**QUALITY ASSURANCE -- NON-CONFORMANCE REPORT**

**Location:** Changxing Island, Shanghai, P.R. China **Report No:** NCR-000337  
**Prime Contractor:** American Bridge/Fluor Enterprises, a JV **Date:** 24-Jun-2009  
**Submitting Contractor:** Zhenhua Port Machinery Company, Ltd (ZPMC), Changxing Island **NCR #:** ZPMC-0311

**Reference Description:** MEP Removal, DP47A, Segment 4BW

项目名称 Project Name	美国海湾大桥 SFOBB	部件图号 Drawing No	4AW/4BW	报告编号 Report No.	B-WR5825
合同号 Contract No.:	04-0120F4	部件名称 Items Name	MEP管 MEP Pipe	NDT报告编号 Report No.of NDT	NA
项目编号 Project No.:	ZP06-787

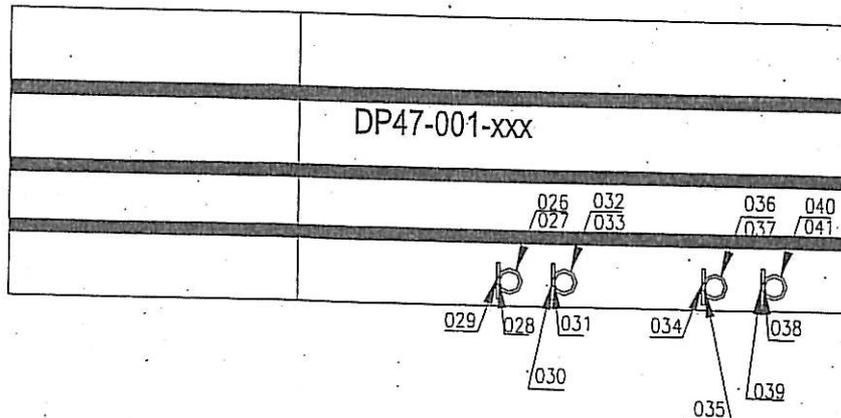
4AW/4BW顶板DP47A上的MEP管装错, 25C装配成25F, PP26-PP28四处(南侧), 现需要刨除。

MEP pipe was assembly error at 4AW/4BW deck plate DP47A; 25c assembly error as 25F, relevant four position form PP26 to PP28 at south side.

Worker didn't review drawing carefully caused assembly error.

1. Remove the MEP pipe by the way of gouging or Oxygen cutting, preheat according to the WPS prior to gouging . do not gouge the base metal.
2. Perform 100%VT inspection of the repaired area.
3. Afresh install MEP pipe , , preheat and weld according to the relevant WPS.
4. Perform VT,MT and UT inspections after welding.
5. Grind and blend the repaired area flush with base metal and adjacent weld.
6. Check the welds according to the working drawings.
